# Wollongong Local Planning Panel Assessment Report | 20 November 2019

<b>WLPP No.</b>	Item No. 3
<b>DA No.</b>	DA-2019/87
<b>Proposal</b>	Construction of a two (2) storey commercial building including fitness centre, swim school, children's recreation facility, neighbourhood shop and approval for two (2) 'pad' sites for fast food restaurant, signage, and associated parking and landscape works in two (2) stages
<b>Property</b>	Lot 1 Windang Road Primbee Lot 1 DP 1093756
<b>Applicant</b>	Revelop Building & Development Pty Ltd
<b>Responsible Team</b>	Development Assessment & Certification - City Centre Team (AS)

## ASSESSMENT REPORT AND RECOMMENDATION

DATE CREATED 17.09.18		A1 SCALE		A3 SCALE As indicated	
																		DRAWING NO 18056		REV D16		REV D

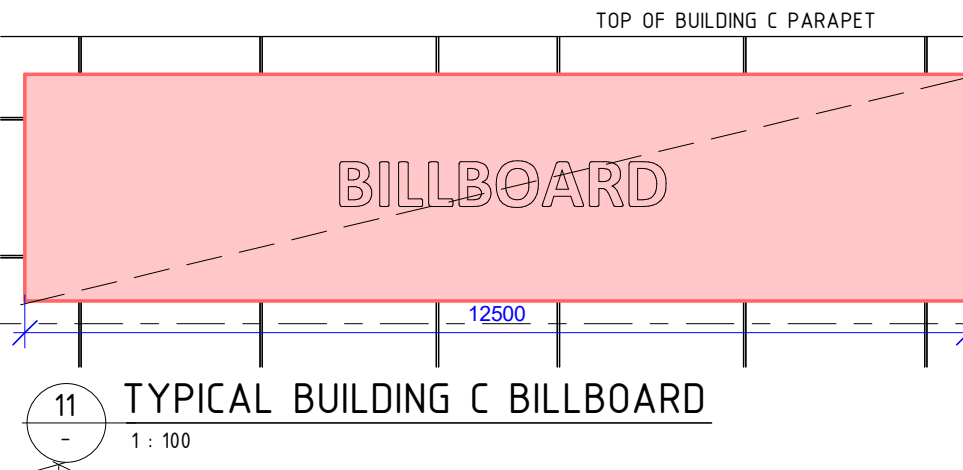
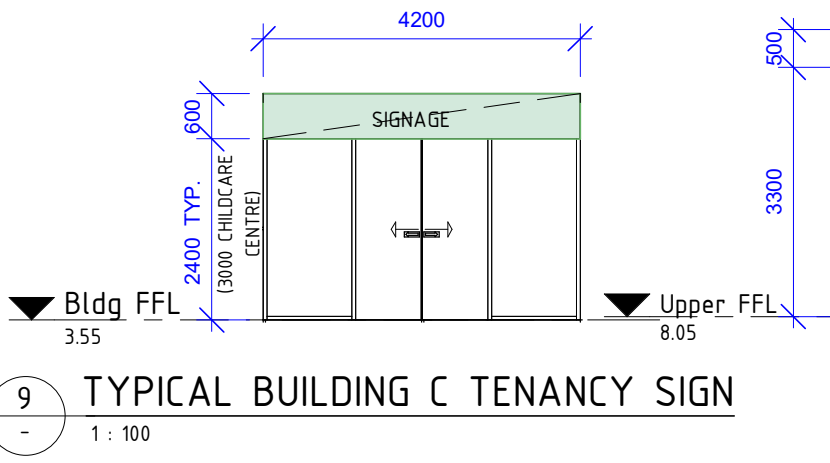
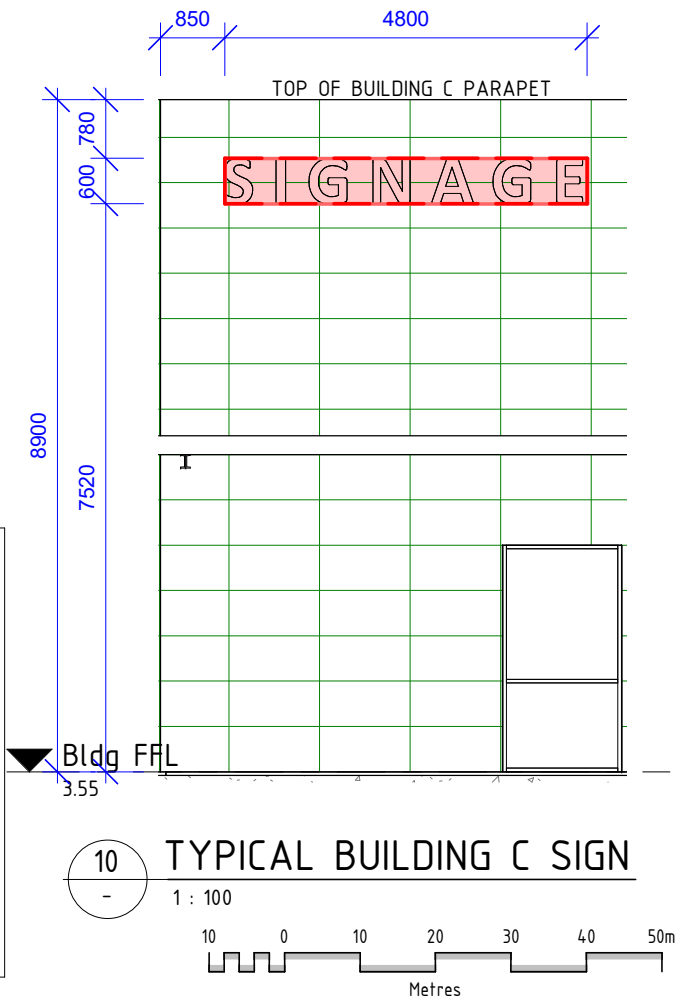
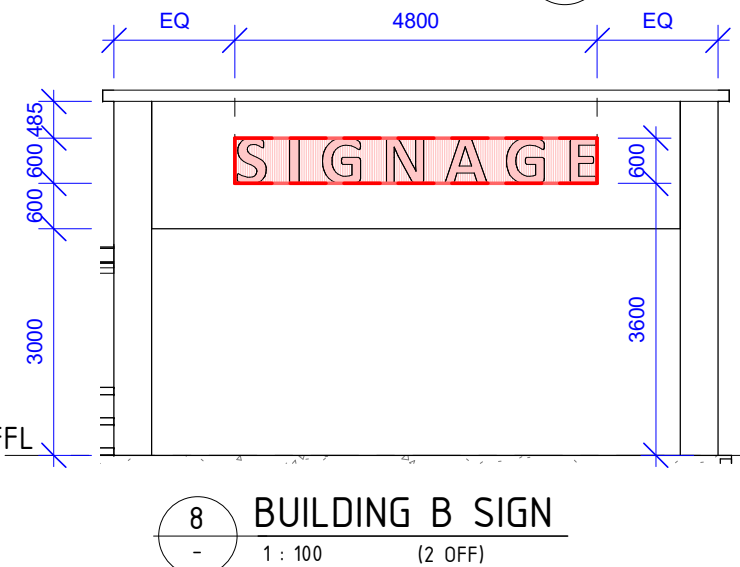
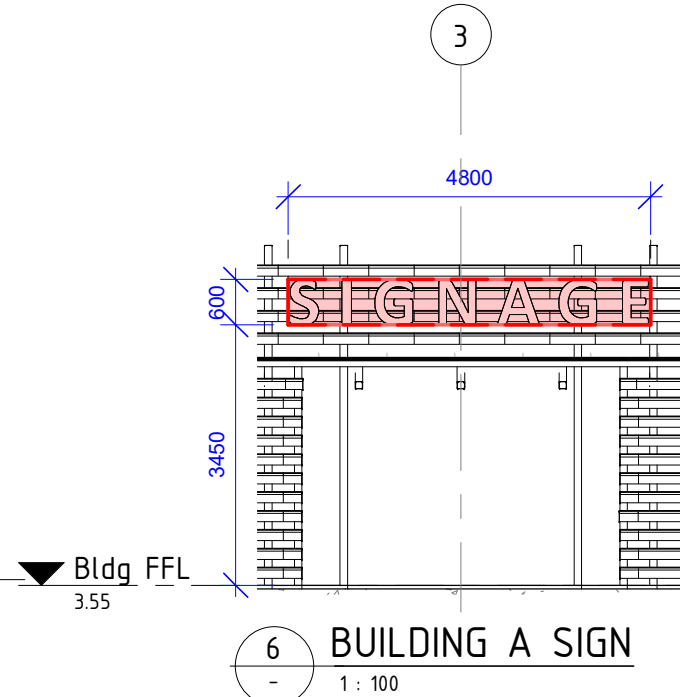
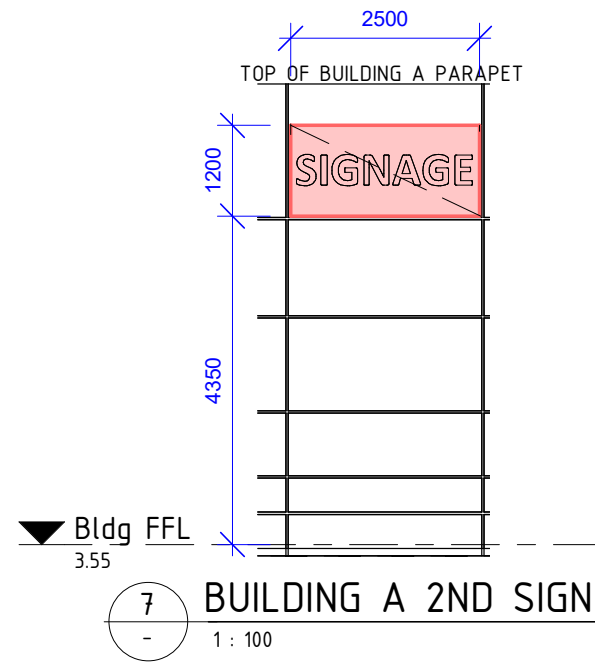
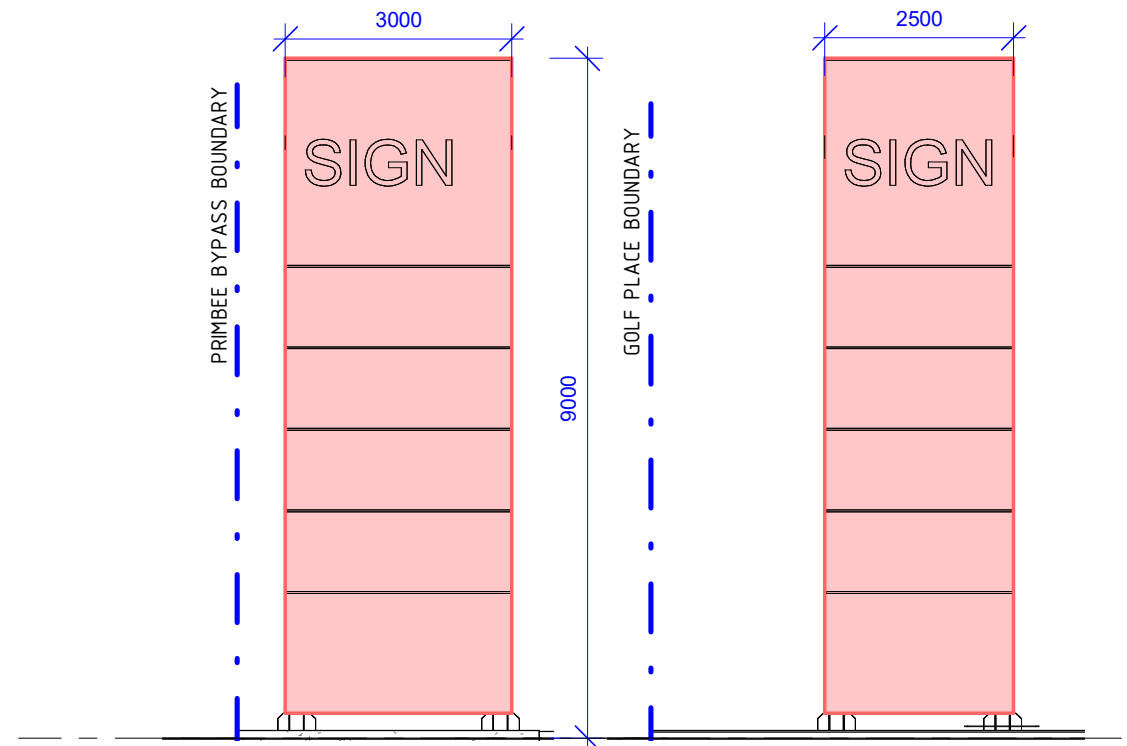
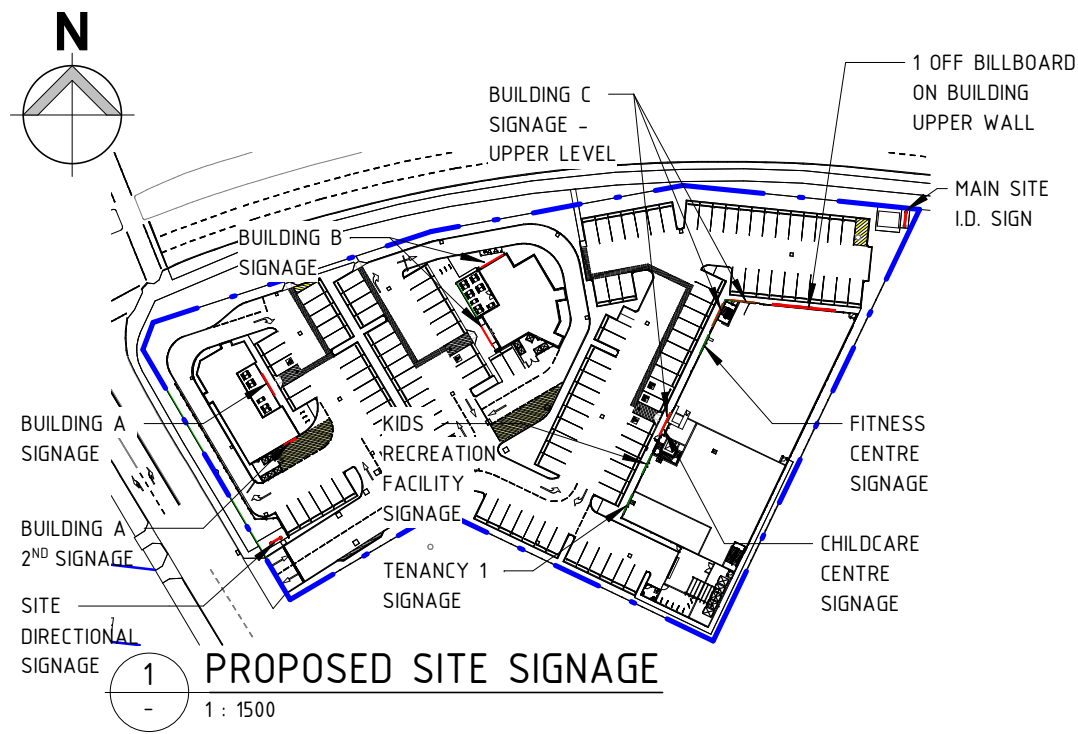
The application involves erection of pylon and building signs (refer plan D016). Signage has been revised since lodgement. Plan D16 contains references to the deleted child care centre.

**Does not comply** – the northern elevation contains a business identification sign at the upper level (refer plan D16) in addition to the billboard.

The billboard is not supported and shall be removed from plans submitted with the Construction Certificate.

LANDSCAPE PLAN

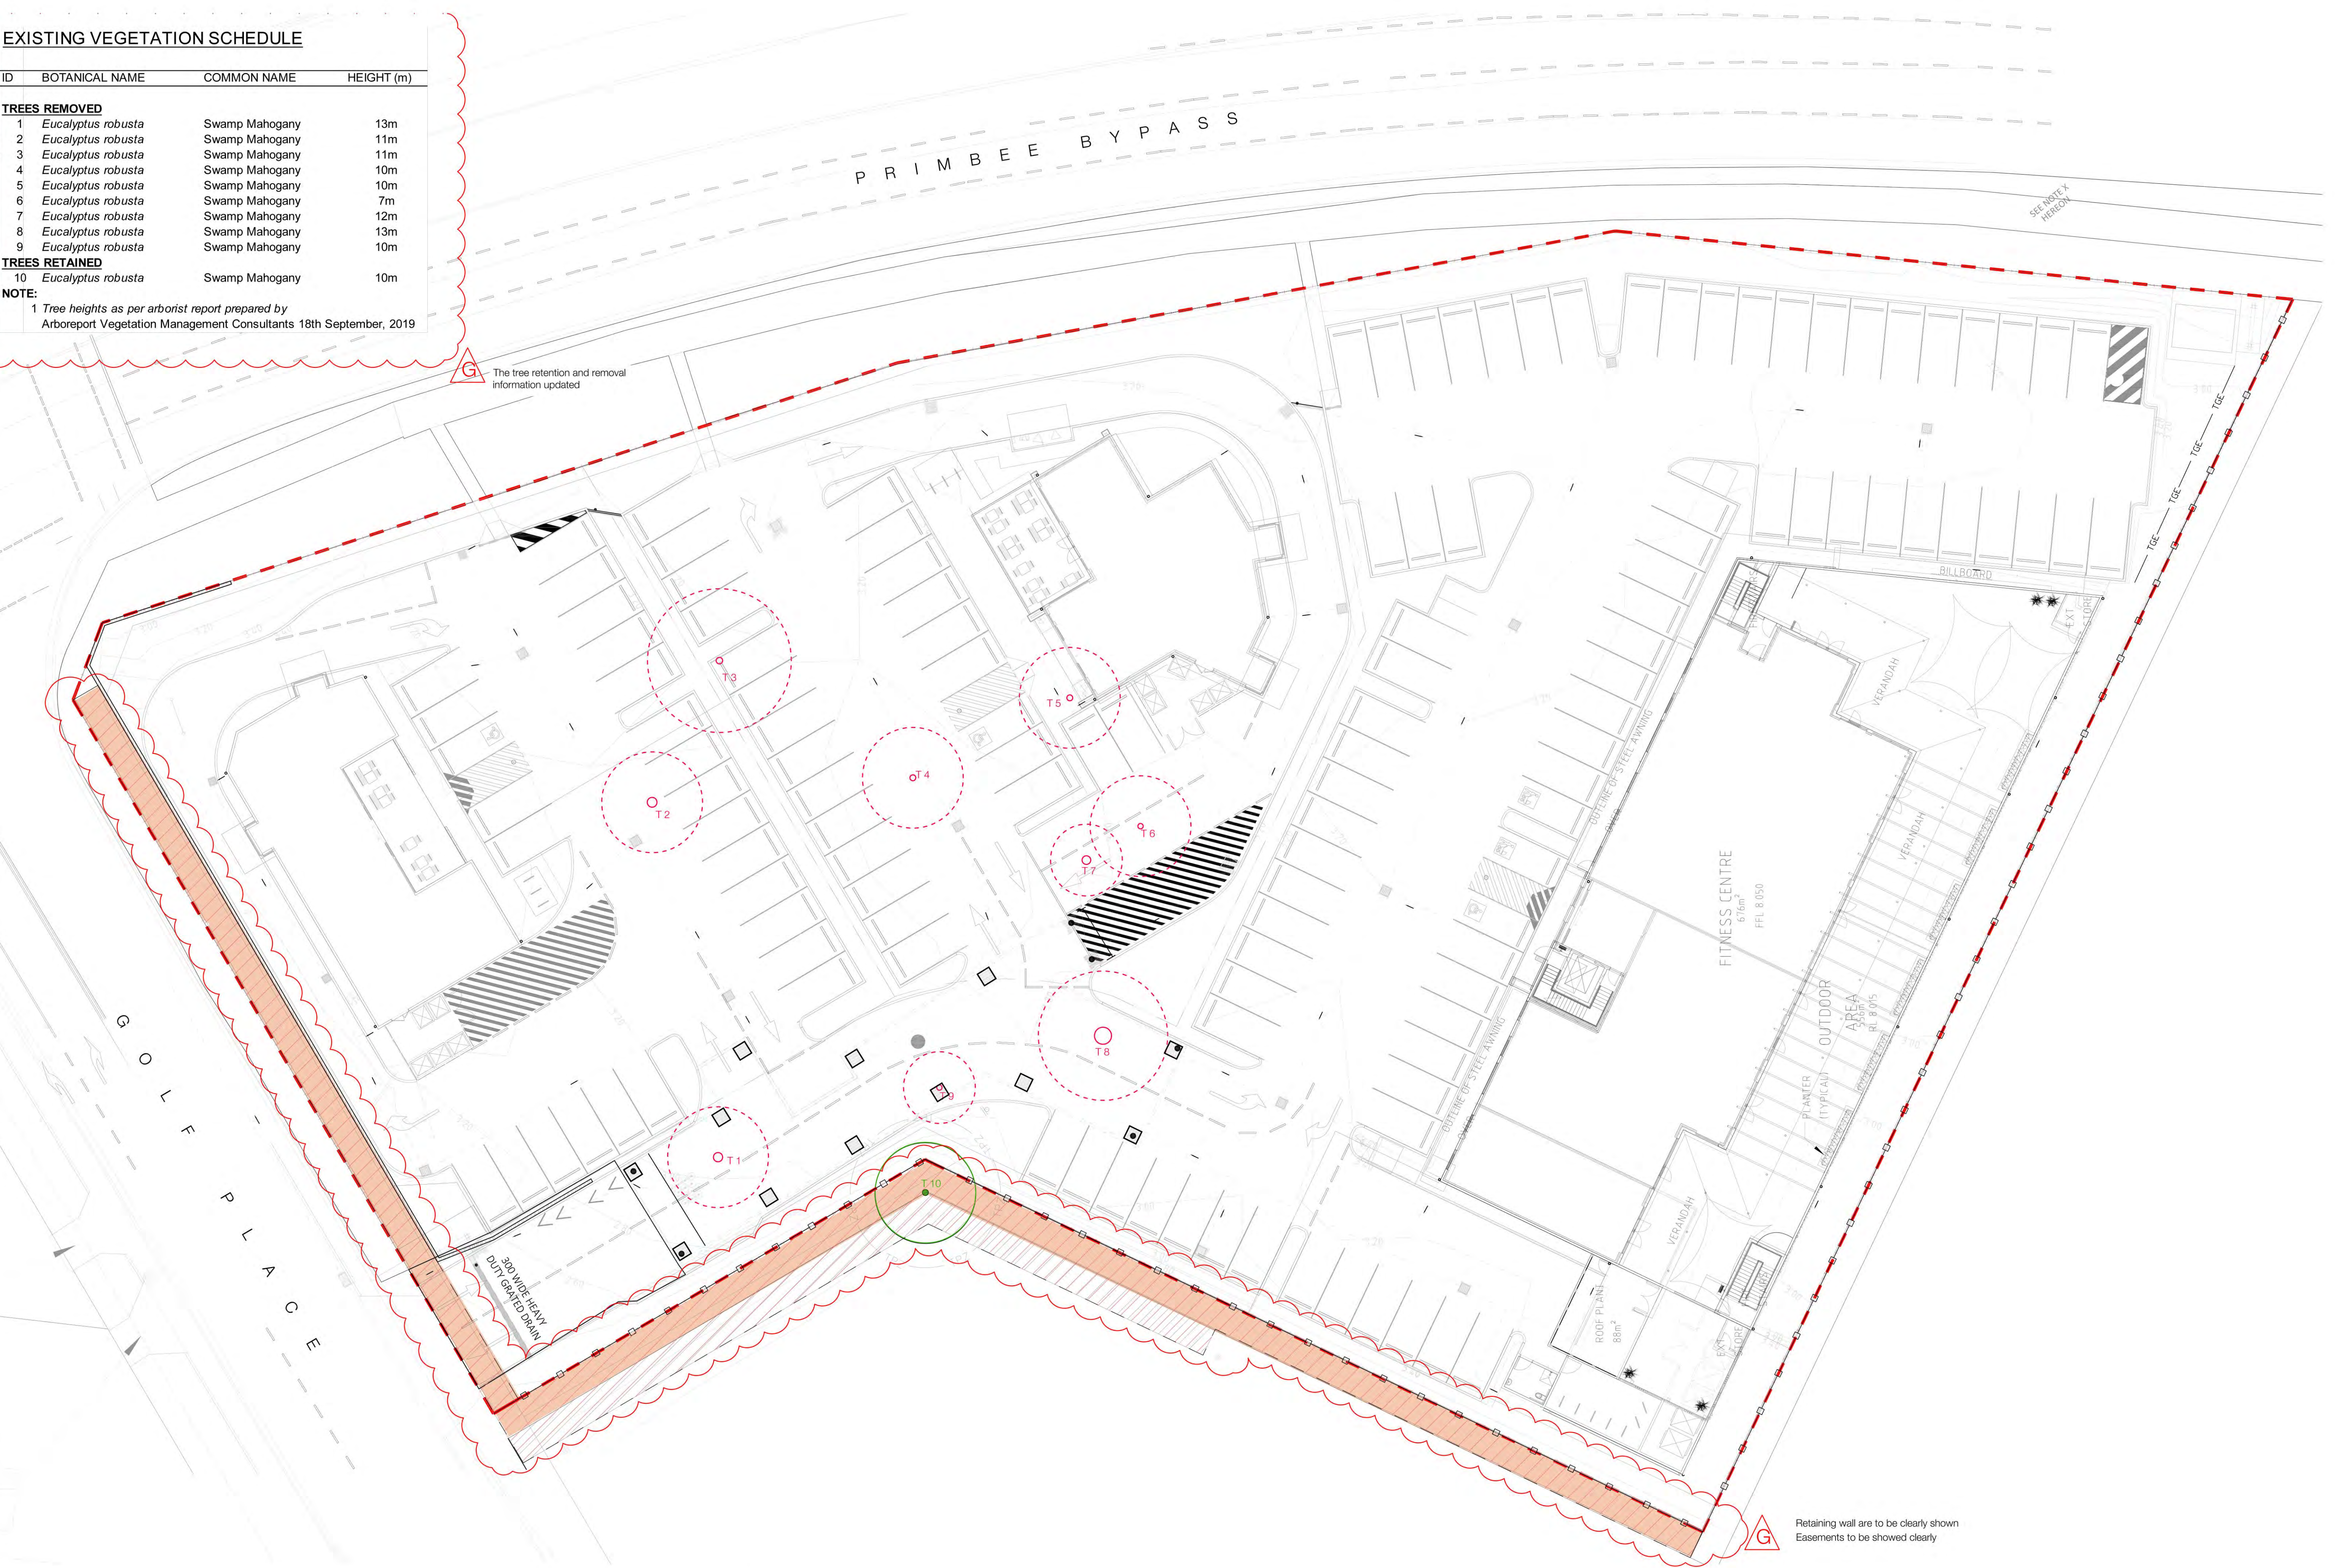
Retaining wall are to be clearly shown  
Easements to be showed clearly

The developer shall retain the existing tree indicated on the Landscape Plan by Taylor Brammer dated 14 October 2019 consisting of tree numbered T10.

This consent permits the removal of trees numbered T1, T2, T3, T4, T5, T6, T7, T8, and T9 as indicated on the Landscape Plan by Taylor Brammer dated 14 October 2019. No other trees shall be removed without prior written approval of Council.

The acoustic fence shown on the approved landscape and site plan is not supported and is to be deleted from Construction Certificate plans.

The landscaping in the reactive barrier easement as shown on the landscape and site plan is not supported and shall be deleted from Construction Certificate plans.

ELEVATION AND PLANTING SCHEDULE PLAN

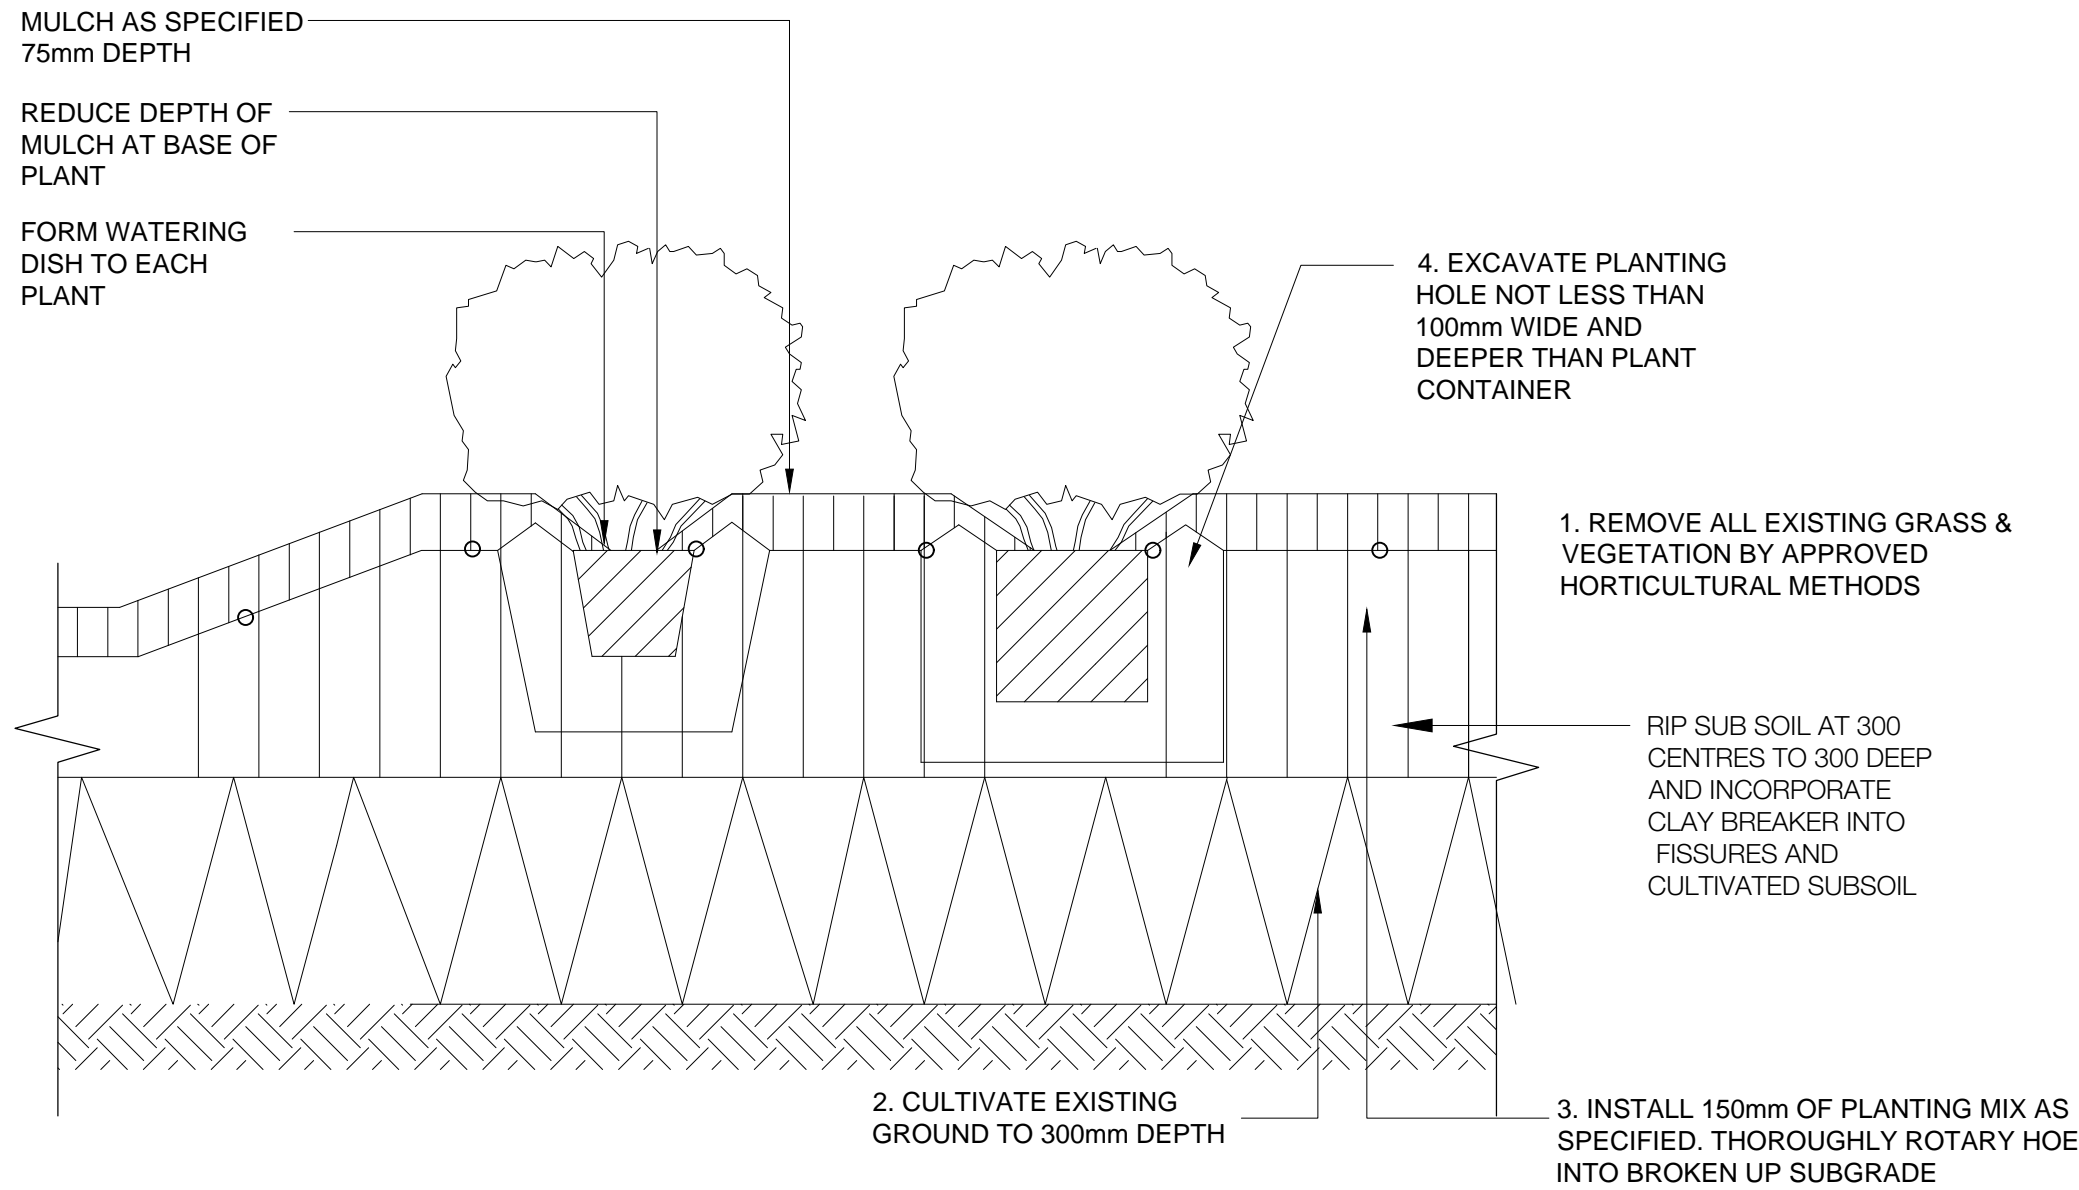
**E** DUE TO OVERUSE AND POOR SUCCESS RATE OF TRISTANIOPSIS LAURINA, BE REPLACED BY FLINDERSIA AUSTRALIS AS PER CONDITION 5.D
